IN THE MATTER OF FLORIDA POWER & LIGHT CO.
ST. LUCIE PLANT, UNIT NO. 2 PETITION FROM HELEN SHEA WELLS

IN THE MATTER OF FPL ST. LUCIE PLANT, UNIT NO.2
PETITION FROM HELEN SHEA WELLS PAGE 2.

FIGURE 2.3 HUTCHINSON ISLAND PLANNING STUDY

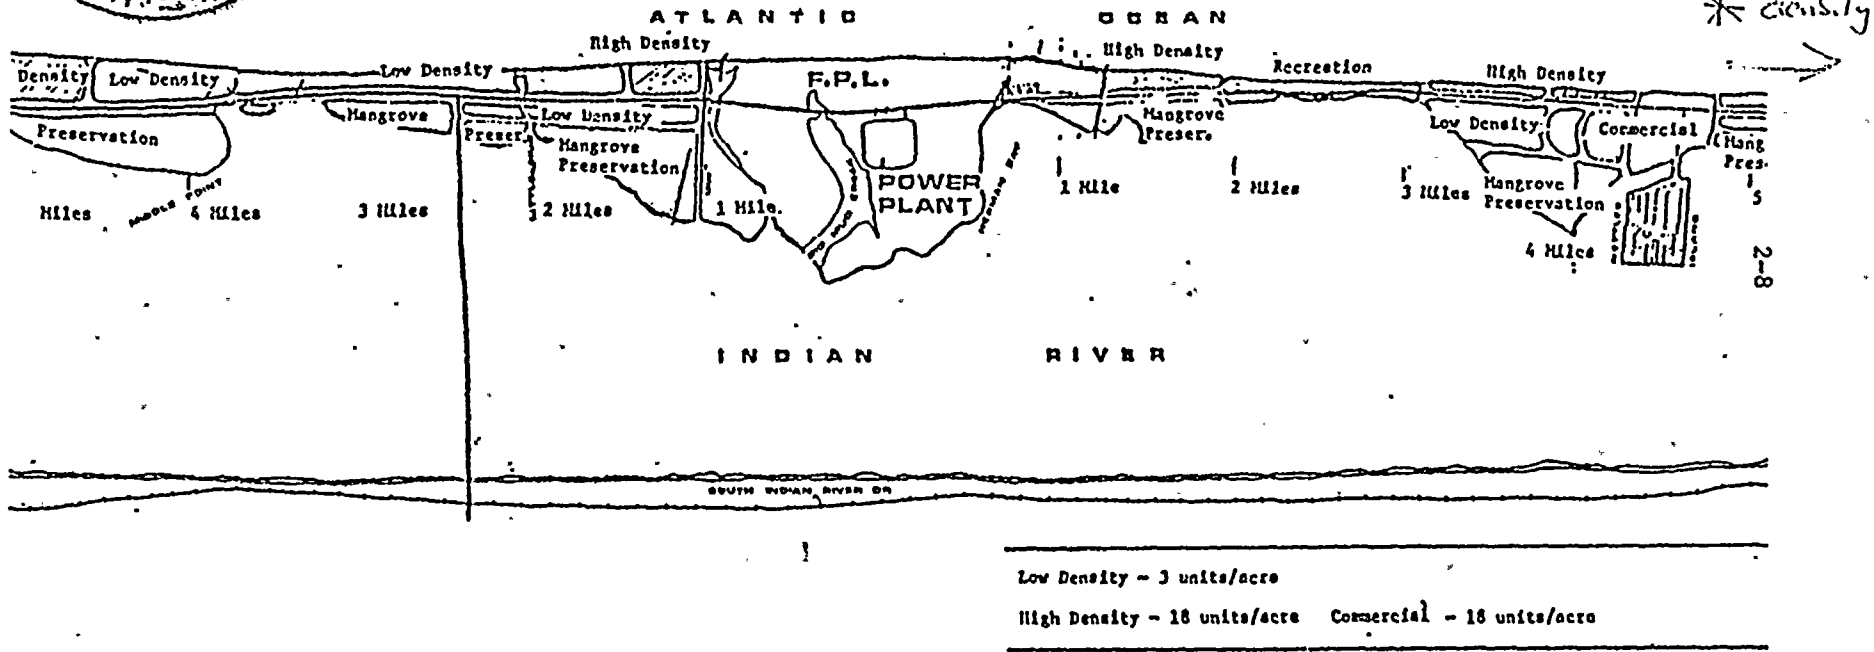
THIS MAP CUTS OFF MOST OF THE AREA WE ARE CONCERNED ABOUT. CONTINUING SOUTH FOR THREE MILES CONTAINS TEN HIGH RISE BUILDINGS, SEVERAL COMMERCIAL SECTIONS ALL CLUSTERED AROUND THE MARTIN CO. BRIDGE (TWO LANE) WHERE ALL THE TRAFFIC FROM THE TWO NUCLEAR PLANTS WOULD HAVE TO EXIT. THIS BRIDGE & ANOTHER ONE FIVE MILES FURTHER SOUTH ARE BOTH IN ANOTHER COUNTY.

This campground is outdoor Resorts of America Nettles Island which 2-5 contains about 3,000 residents!!

This beach & park are in Martin County
